**SUBDIVISION COMMITTEE  
METROPOLITAN AREA PLANNING COMMISSION**

**STAFF REPORT  
(Preliminary Plat)**

CASE NUMBER: S/D 93-53 THE TREE FARM ADDITION

**CASE NUMBER:** S/D 95-38 HEDGEAPPLE ADDITION

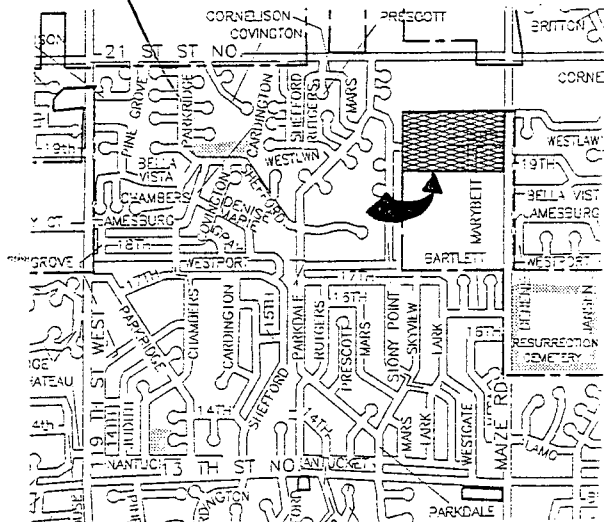
- H. Traffic Engineering needs to comment upon the street offsets at Maize Road being created by this plat and the site east of Maize Road. Both the 20th Street and the Westlawn/19th Street offsets are below the 150-foot minimum noted in the Subdivision Regulations. In addition to potential conflicts for vehicles entering Maize Road from these streets, the Westlawn/19th Street alignment can cause significant conflicts for cars on Maize Road making left turns into these sites. Cars making simultaneous left turns in such situations can easily block each other, causing a hazardous

backup of traffic.

As necessary, the final plat should be redesigned to eliminate any such street offsets/jogs determined hazardous. Westlawn could for example be terminated in a cul-de-sac just west of Maize Road.

- L. The configuration of Lot 10, Block 1 is somewhat awkward in particular as to the rear of the lot being forced to such a narrow shape. It is recommended that a shift in the common lot line of Lots 9 and 10 be considered such that Lot 9 increases its frontage to 20th Street while decreasing its rearyard such that Lot 10's rearyard is increased.

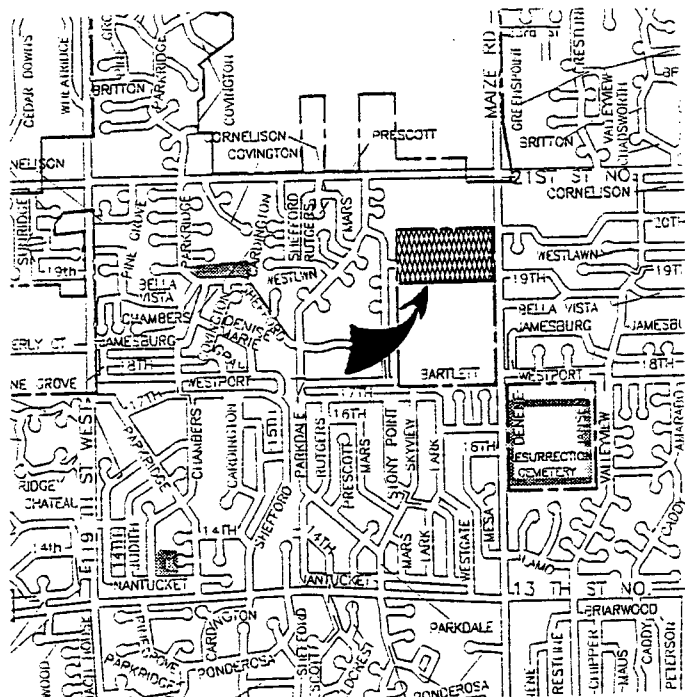
- F. The applicant shall guarantee the paving of the proposed interior streets. This guarantee shall also provide for sidewalk along one side (preferably north) of Westlawn/Skyview.

- M. The representative(s) from the **Fire Department** and/or **OCI** need to comment if the change in street names from Westlawn to Skyview to Westlawn is appropriate. The street stubs at the southwest corner of this plat do appear to require the use of two names even though a basically continuous street is involved.
